Development Review Comments

PAM2024-00154

1st Submission Review Comments

205 Park Road

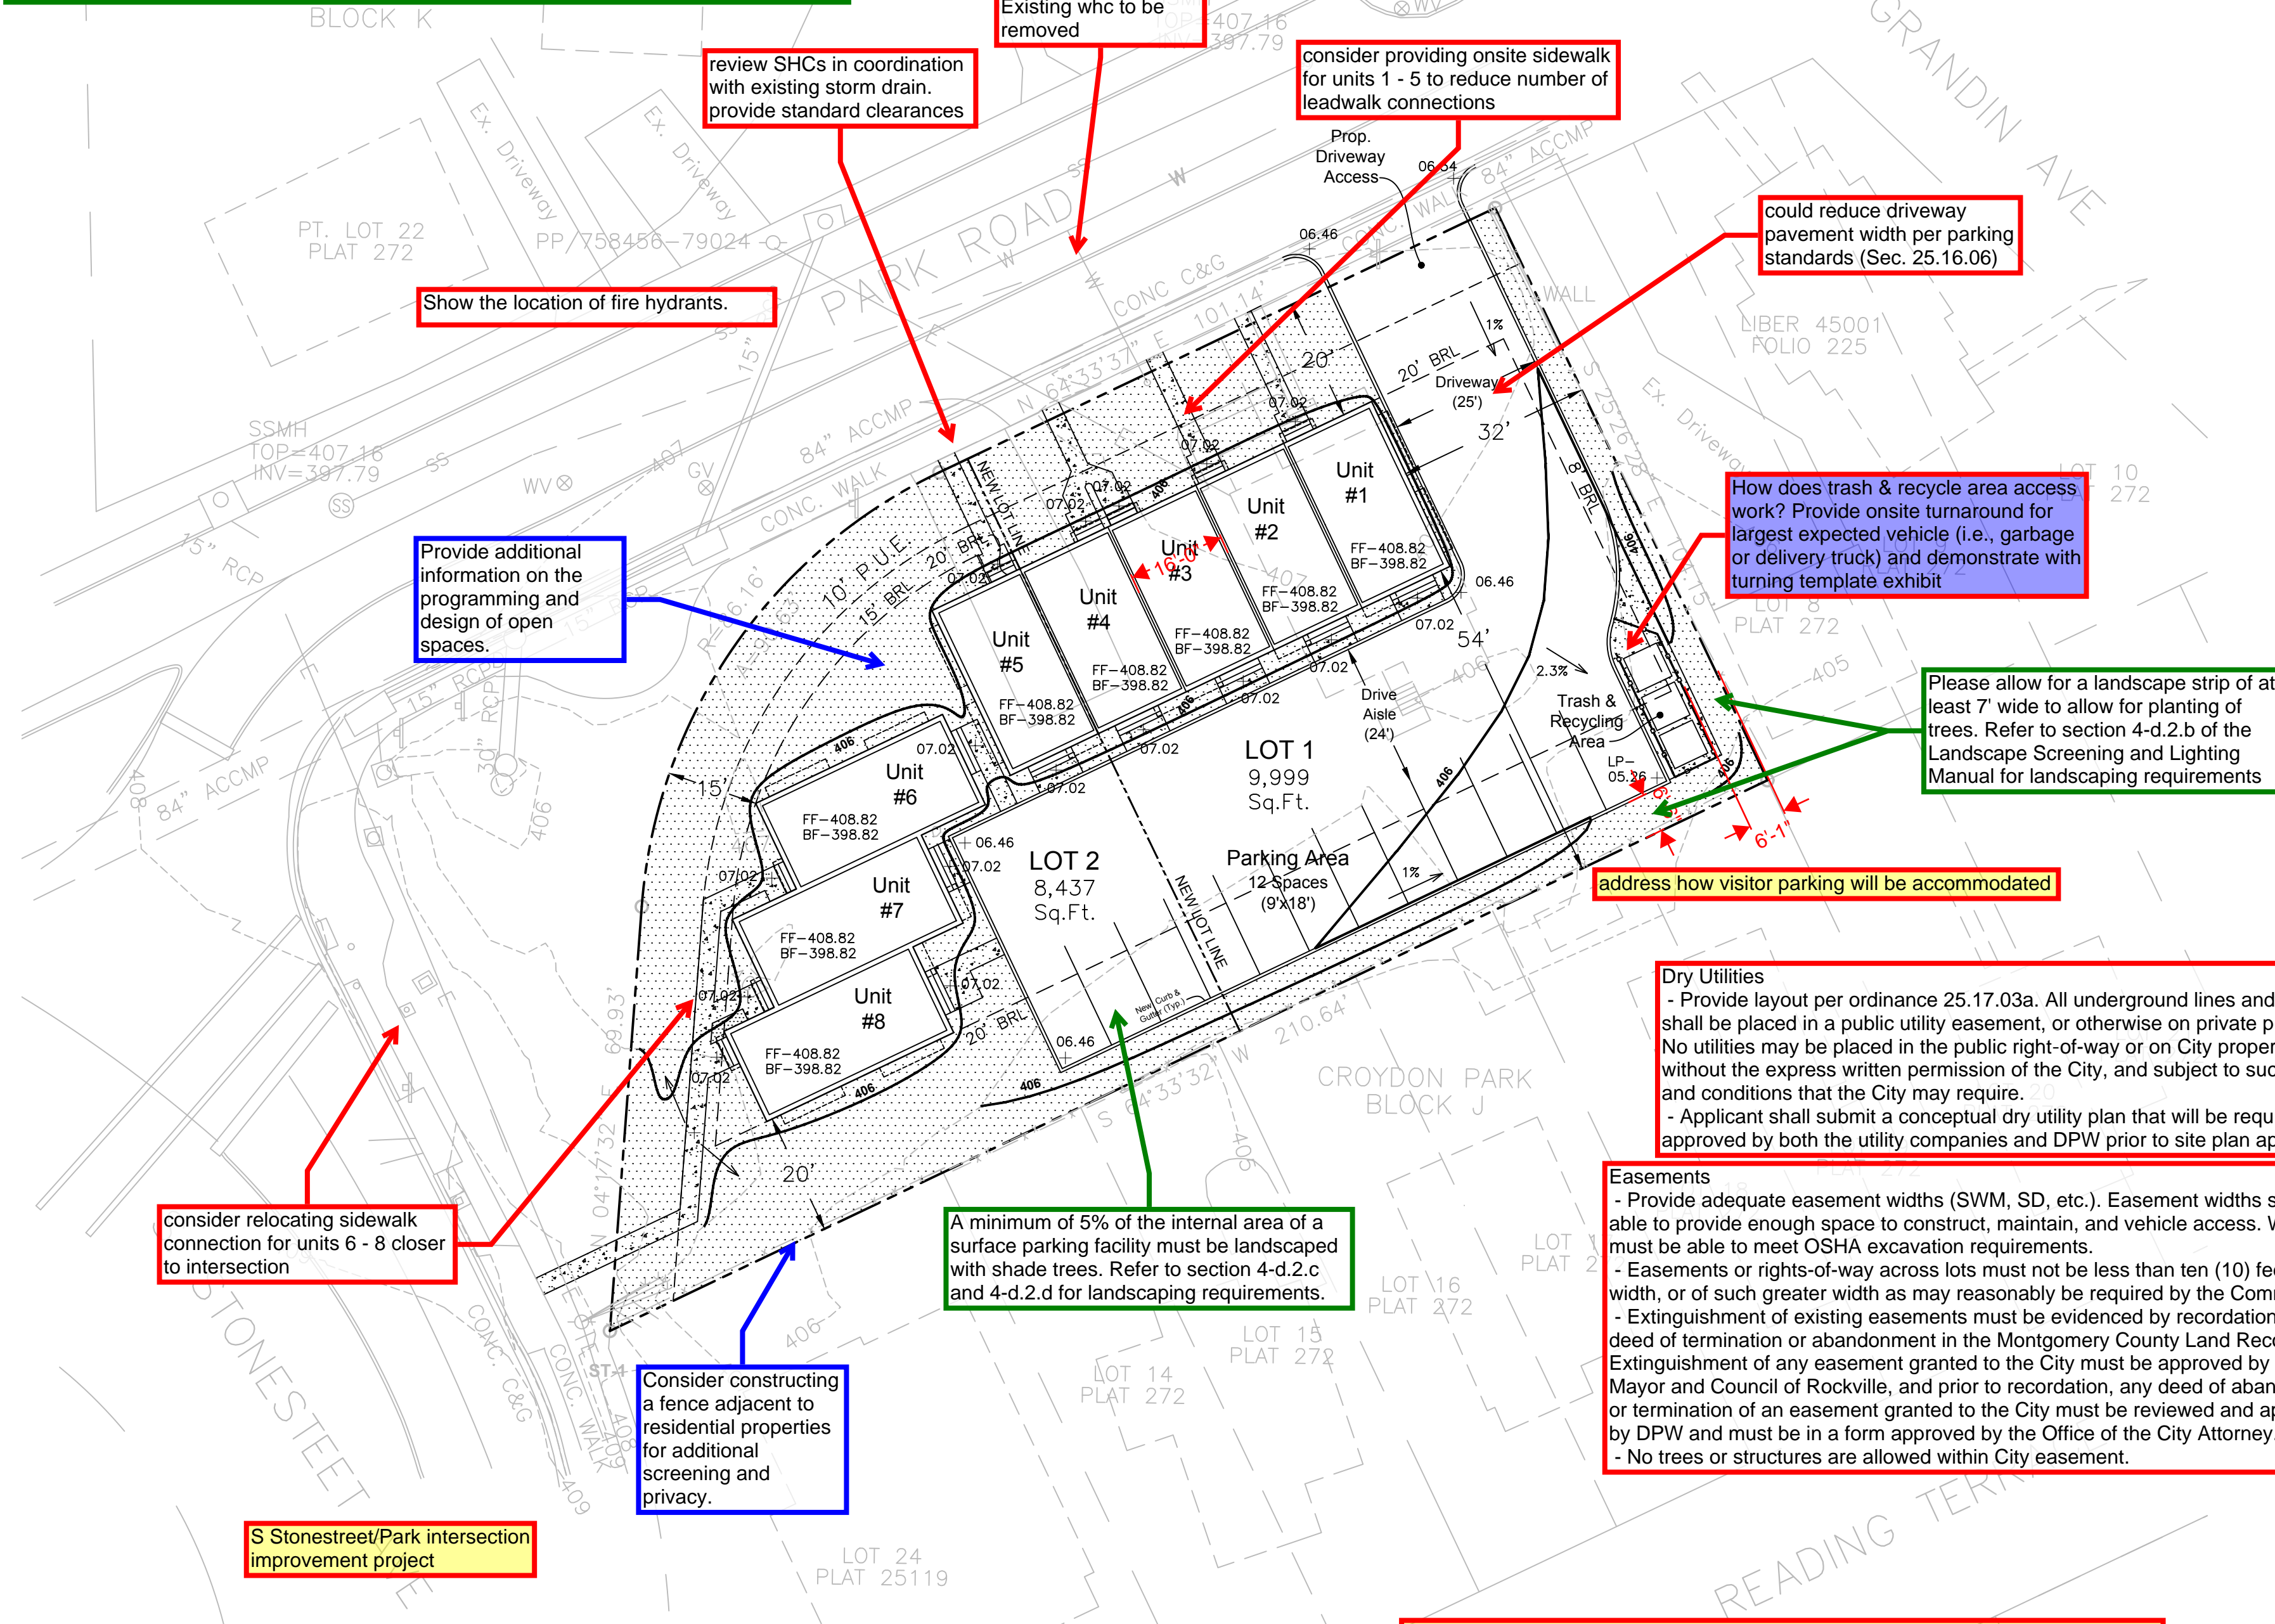
1. During construction make sure artwork is protected. See below location of artwork.

PRELIMINARY SITE PLAN
CROYDON PARK
LOTS 1-7, BLOCK J - 205 PARK ROAD
City of Rockville, Maryland

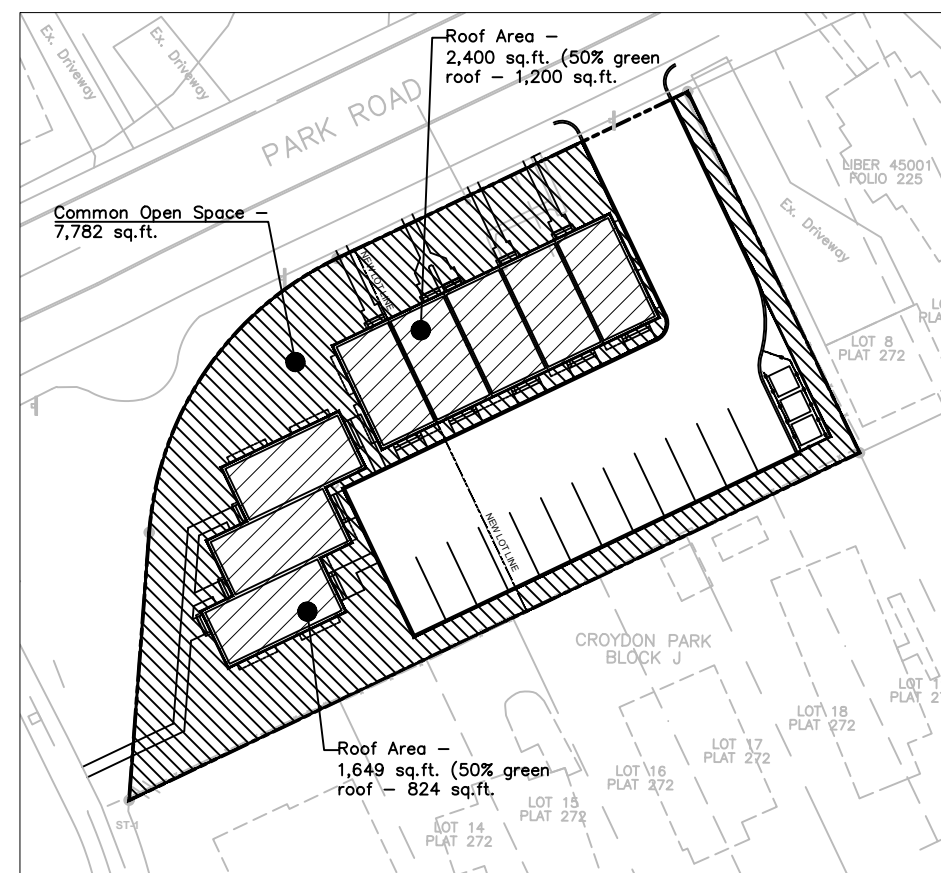
An NRI/FSD for this development was approved by CPDS on November 4, 2022. A Forest Conservation Plan (FCP) will be required to authorize removal and impacts to existing significant trees. All forest conservation, significant tree replacement, and minimum tree cover requirements will need to be met in the FCP per Chapter 10.5 of the City Code.

Staff would like to inform the applicant that due to recently adopted State legislation (SB0526), the City of Rockville is in the process of amending Chapter 10.5 Forest and Tree Preservation Ordinance (FTPO) of the City Code. Please note that after the FTPO is amended, forestry requirements may change.

This development must also comply with the City Landscape Screening and Lighting Manual. Refer to Section 4.d.b.4.b.d for landscape requirements.

Stormwater Management
- The Pre-App SWM Concept must be approved prior to submission of the Site Plan.
- The Pre-App SWM Approval letter will establish percent of ESD required and safe conveyance analysis.
- The Development Stormwater Management Concept must be approved prior to Site Plan approval.
- The SWM Construction Plans (Permit) cannot be submitted until the Site Plan is approved

Sediment Control
- Preliminary Sediment Control Plan must be approved prior to Site Plan approval.
- A Sediment Control Construction Plan cannot be submitted until the Site Plan is approved.
- A Sediment Control Construction Plan will not be approved until the corresponding Signature Set Site Plan is approved.
- Sediment Control Permit will not be issued and tree removal or Clearing cannot commence until the Forestry Permit, if required by Chapter 10.5 (Forest and Tree Preservation), is issued.

Safe Conveyance
- Safe Conveyance Study must be approved prior to site plan approval. The Pre-App SWM Approval letter will establish the study points of the safe conveyance analysis. However, this analysis may be concurrent with the Development SWM Concept.

Water and Sewer Authorization must be approved prior to site plan approval. WSA application has been received and is under review for deminimis increase.

Provide space for outside water meter. Provide space for sewer connections and cleanouts

Multiple condominiums located on a lot, ownership lot, or parcel of land which are configured as single-family dwelling units shall be served by separate City water and sewer service lines from the City main to each condominium, as approved by the Director and the Chief of ISD (Sec. 24-32(a)(4))
